**SUBJECT: ERRATA – WESTINGHOUSE ELECTRIC COMPANY – NUCLEAR
REGULATORY COMMISSION INTEGRATED INSPECTION REPORT NUMBER
70-1151/2018-004 AND NOTICE OF VIOLATION**

Report No.: 70-1151/2018-004

Facility: Columbia Fuel Fabrication Facility

Cross-sectional View of HF Spiking Station

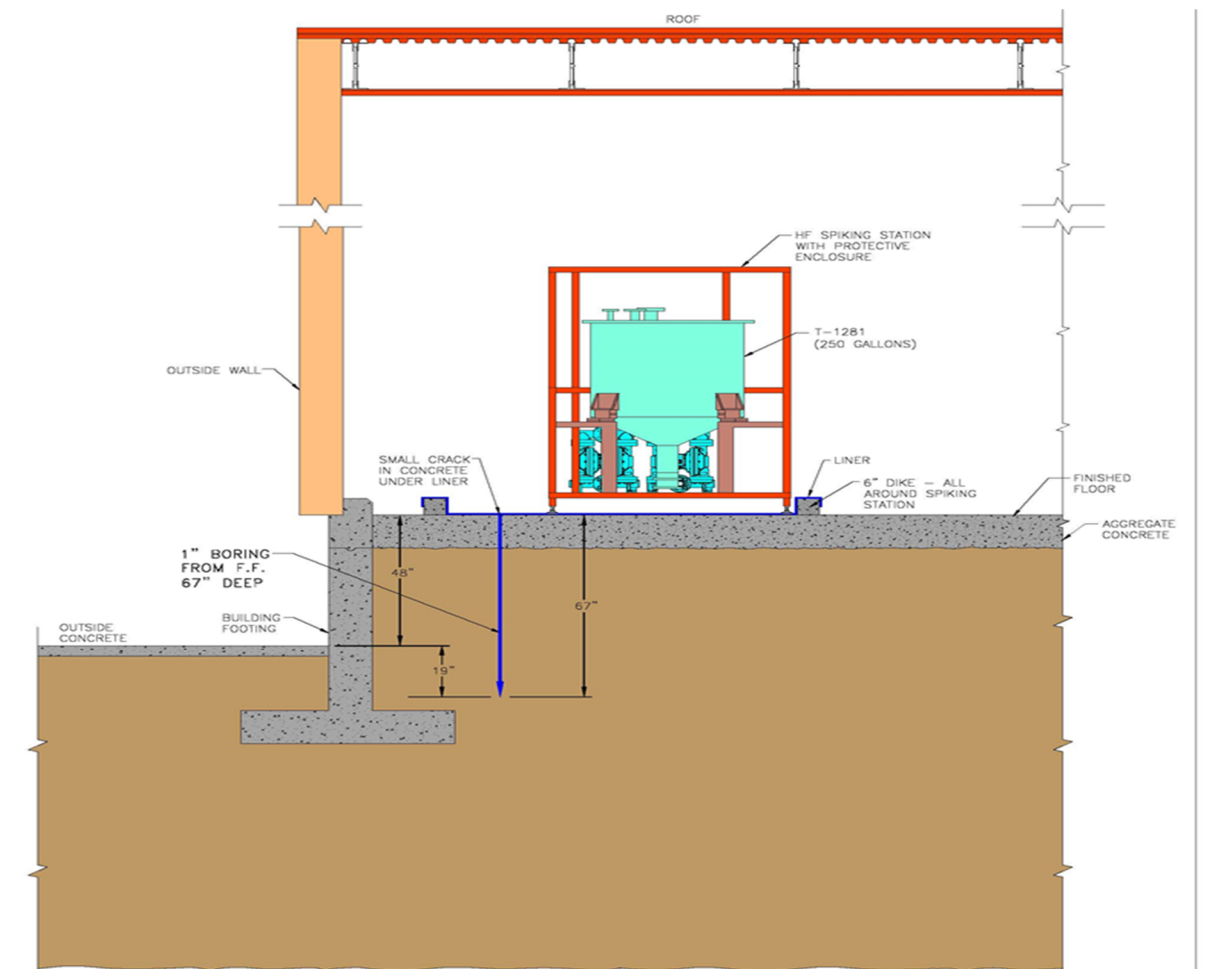
Description: On June 16, 2018, approximately 30 gallons of UNH solution leaked into the diked area surrounding the HF spiking station. A flanged piping connection was the source of the leaking solution. After the system was shutdown, a worker identified a small amount of solution that appeared to have migrated to the outside of the dike wall. CAP 2018-11205 was written to track the issue and Spiking Station #2 was shut down. The dike liner was removed as part of corrective measures. While the polypropylene liner was removed for repair work, a small crack was noticed in the epoxy floor covering. The plan was to repair the crack but as the loose epoxy was chipped away, a hole of approximately 3 inch diameter was revealed.

ADUHFS-502 had management measures applied in the form annual inspections of the piping structural integrity in accordance with OM81217. These annual inspections consist of visual inspections of all connection points for possible leaks, corroded flanges, corroded bolting and supports. The HF Spiking Station did not have an operating maintenance/preventative maintenance (OM/PM) established for the type of couplings that leaked on the HF Spiking Station even though it was recommended by the manufacturer.

ADUHFS-902 had management measures applied in the form of annual inspections of the liner in accordance with OM 81215, “SI-Safety, HF Spiking Station Pad Liner.” These inspections check the dike liner for evidence of tears, penetrations, or seam separation. The inspectors reviewed the three previous year’s inspection results and noted that the inspections failed to identify the degraded condition of the liner. A review of the liner following the event indicated a penetration through the liner which allowed UNH to migrate to between the liner and the concrete floor. In addition, the inspectors noted that portions of the liner had been previously repaired with numerous patches,

indicating that damage to the liner had occurred in the past. The inspectors noted that the annual inspection provides repair instructions, however, testing of the liner is not conducted following repairs.

ADUHFS-902 was considered degraded as indicated by cracks and degradation of the concrete dike wall. The inspectors noted that there was no policy or procedure in place to periodically inspect the area below the liner for indications of degradation of the concrete floor due to liner leaks.

- OM81215 was updated to 1) clarify the steps needed to perform the liner leak check, 2) require notification to Environmental Health and Safety (EH&S) of any degradation, and 3) change the frequency of the inspection from annual to quarterly and following any repair.
- The Spiking Station was barricaded and posted with instructions to put down walking pads prior to stepping on the liner to prevent liner damage.
- Hourly inspections of the liner have been commenced while the spiking station is in operation.

- Develop and implement an improved design for the spiking station system and dike area including a design review to prevent UNH solution from impacting the environment.
- Assess similar design configurations of a liner/environmental barrier relied on for secondary containment for proper post-maintenance and time-based PMs.
- Conduct an extent of condition for similar couplings used throughout the facility to verify PMs have been established.
- Additional long term corrective actions are detailed in ACA 2018-12123.
